PERIPHERAL EQUIPMENT DIVISION

TITLE +10 VOLT SUPPLY OSCILLATIONS				PIB NO. DK3033	
PRODUCT LINE:		EQUIPMENT CHANGED Servo PCBA 102811		MODEL SERIES AFFECTED D3000	
TAPE DISK FORMATTER				EFFECTIVE DATE 3/28/75

V. REWORK INSTRUCTIONS: Servo PCBA (102811)

FIGURE 1

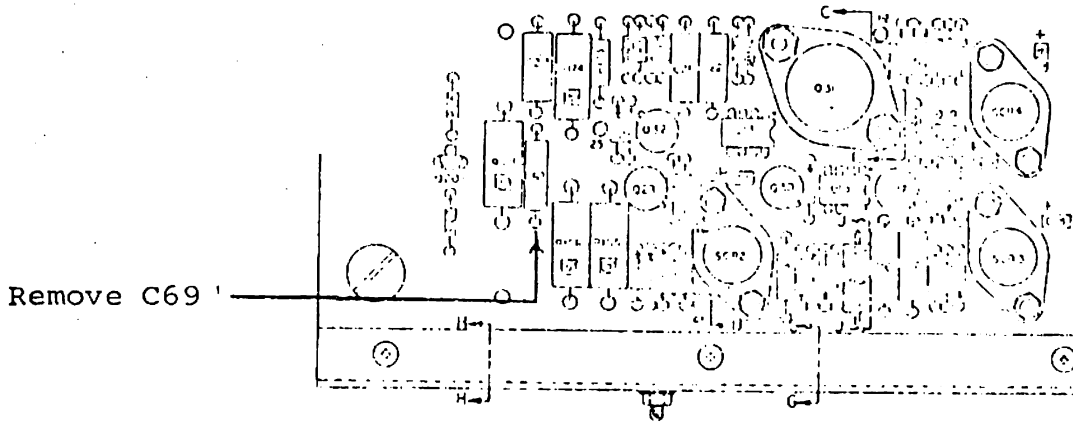
1.1 Remove .001 ufd capacitor designated as C69. (See Figure 1)

FIGURE 2

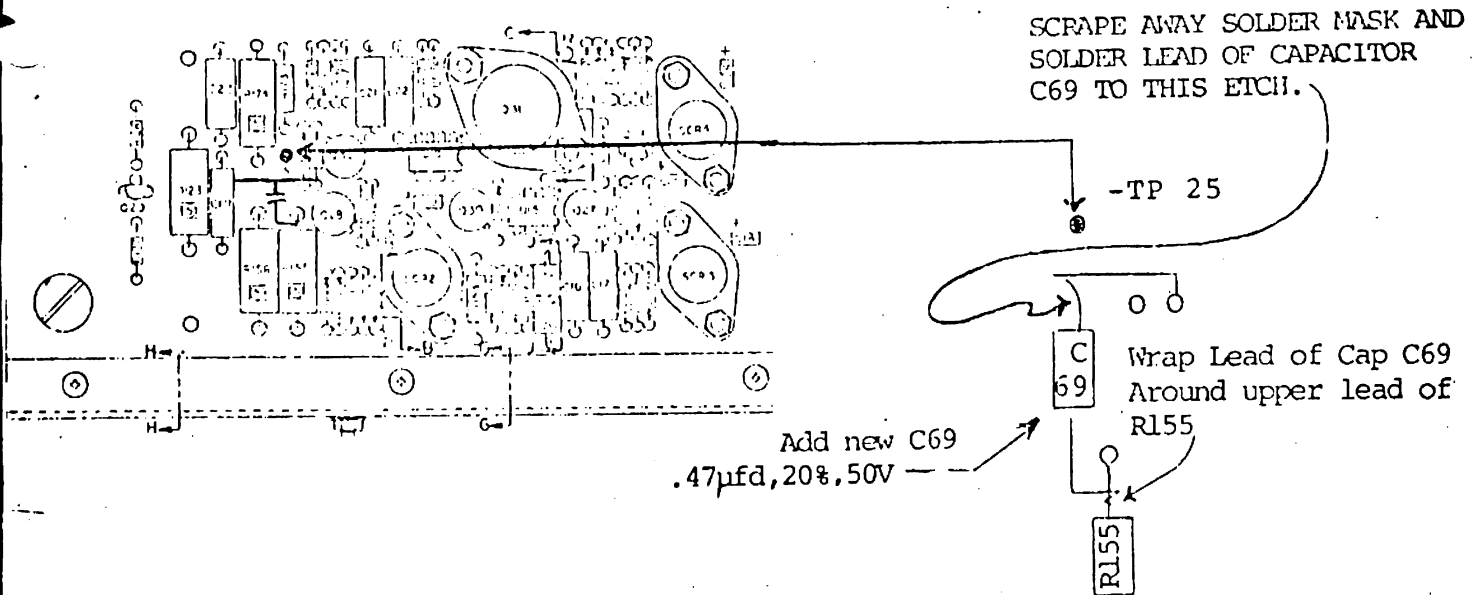
2.0 Add new C69 as shown in Figure 2.

FIGURE 3

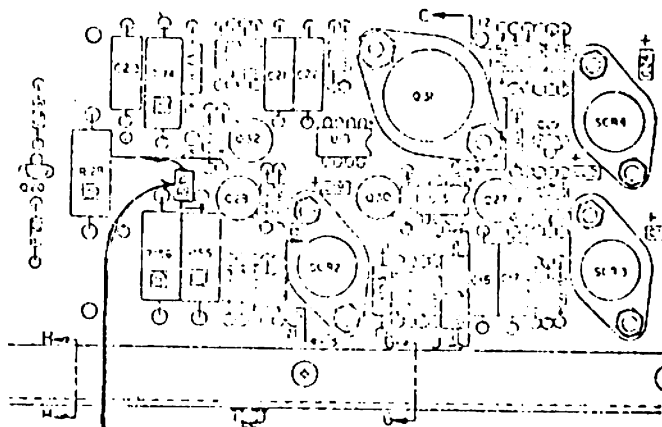
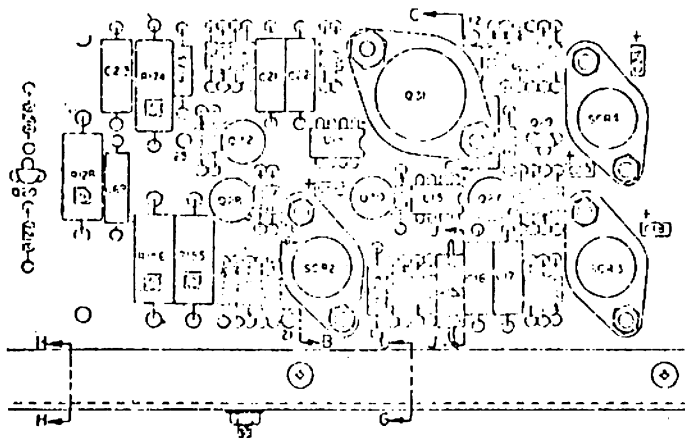
B. DWG NO. 102822, Sheet 1 of 1

2.0 Zone D-7 - Change as shown in Figure 3

NOTE: NO REVISION CHANGE IN PRINT NECESSARY.
MARK PRINT 102811 AS SHOWN IN FIGURE 3.

FIGURE 4

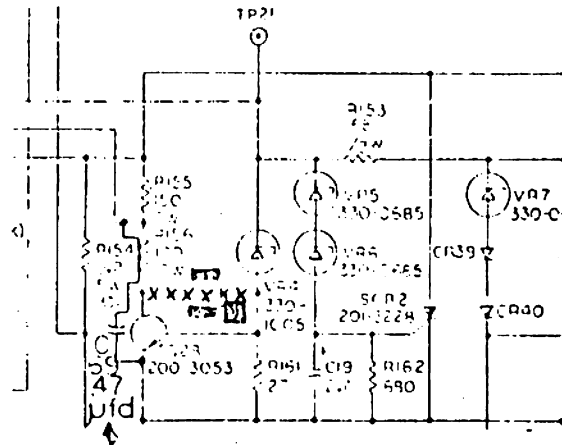
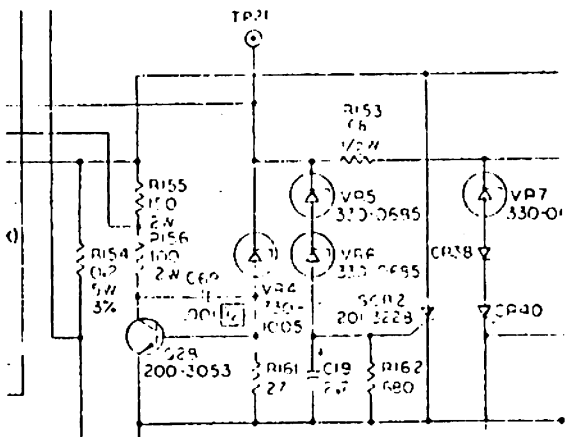
C. DWG NO. 102810, Sheet 2 of 3

1.0 Zone F-15 - Change as shown in Figure 4

NOTE: No Revision Change in Print Necessary.
Print 102810, Sheet 2 of 3, as Shown
In Figure 4.
